Work Order ID 95443

Item Name: Crosstube Fwd

DRAWING NO. D206-667-141	TITLE CROSSTUBE ASS'Y (206B HIGH FWD)	REV. C	<b>DART AEROSPACE LTD ENGINEERING ORDER</b>		D.E.O. NO. D206-667-141-C-1	SHEET NO. SHEET 1 OF 1	SCALE NTS
DRAWN 9	CHECKED ASS	MFG. APPR. 10	APPROVED WD		DE APPR. H		
DATE 11.07.15	DATE 11.07.20	DATE 11.07.21	DATE 11/67/21		DATE 11.07.21

DRAWING NO. D206-667-141	TITLE CROSSTUBE ASS'Y (206B HIGH FWD)	REV. C	DART AEROSPACE LTD ENGINEERING ORDER		D.E.O. NO. D206-667-141-C-2	SHEET NO. SHEET 1 OF 1	SCALE NTS
DRAWN AJS	CHECKED J	MFG. APPR. E	APPROVED AP		DE APPR. H		
DATE 12.08.02	DATE 12.08.02	DATE 12.08.02	DATE 12.08.02		DATE 12.08.02

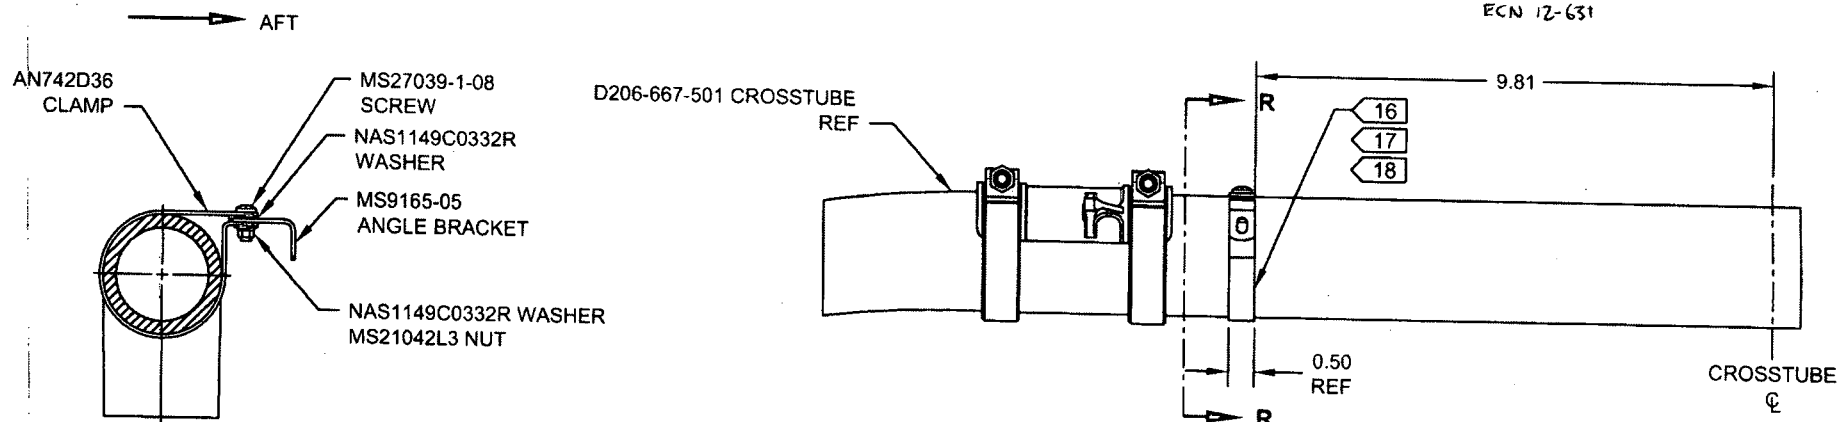
ADD ELECTRICAL GROUNDING STRAP

ADD
